REFERENCE	BT_2010_FR20_22_UK
DATE	5 th October 2010
SUBJECT	New ECU software release 2010.3, gearbox casing
PART	ECU, gearbox casing

1. New ECU software release 2010.3

2. Gearbox casings crack

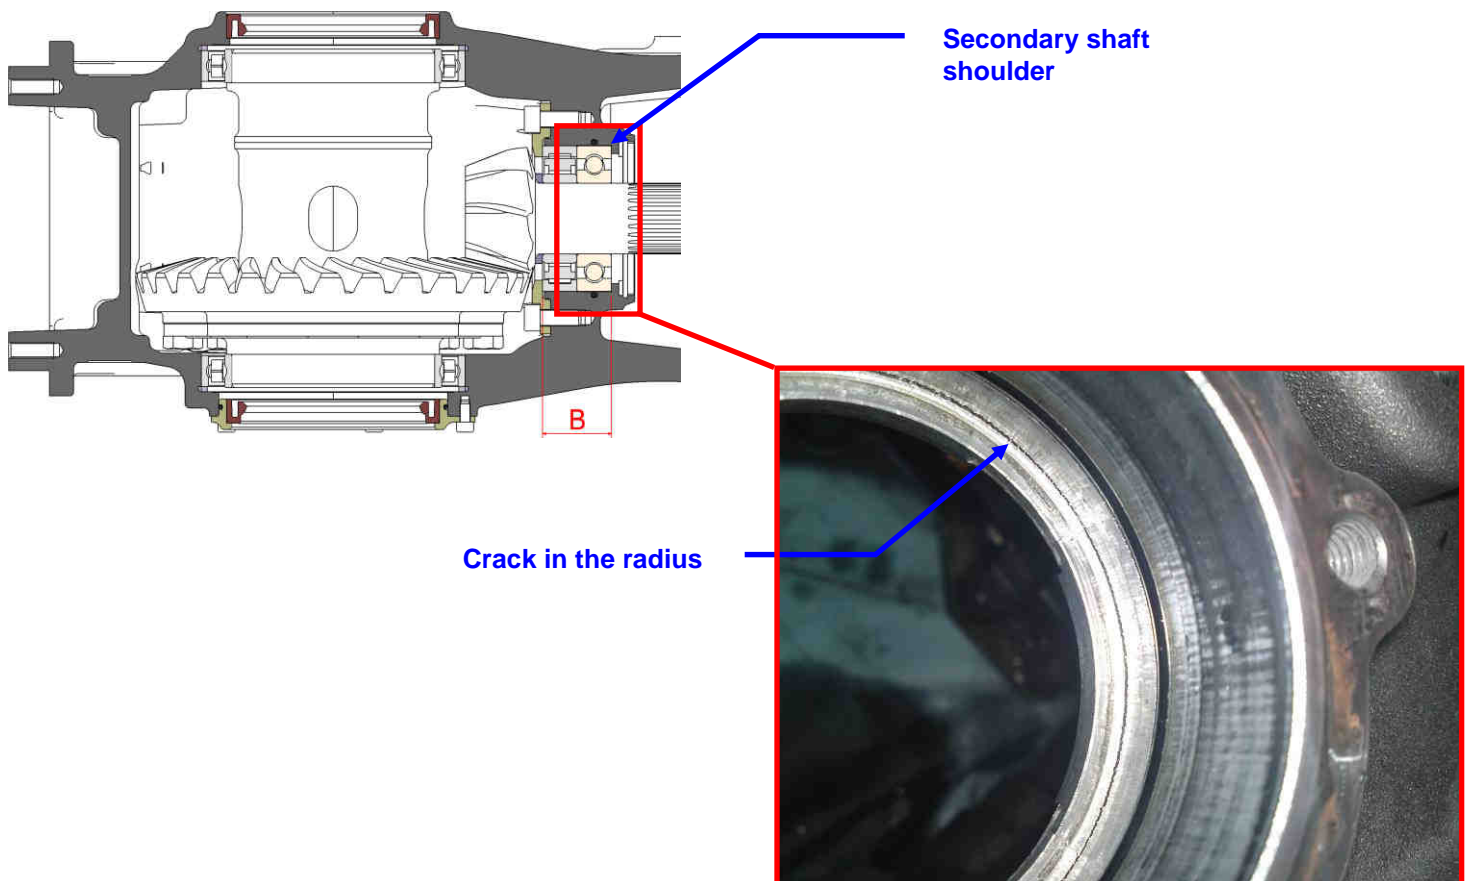
- b. There was no default value when the fuel pressure sensor was in default or disconnected. This problem has been corrected and the default value is set at 3.5bars.

Note: as all the other sensors, when the fuel pressure sensor is disconnected or in default, the default value will be written in blue on the dashboard screen.
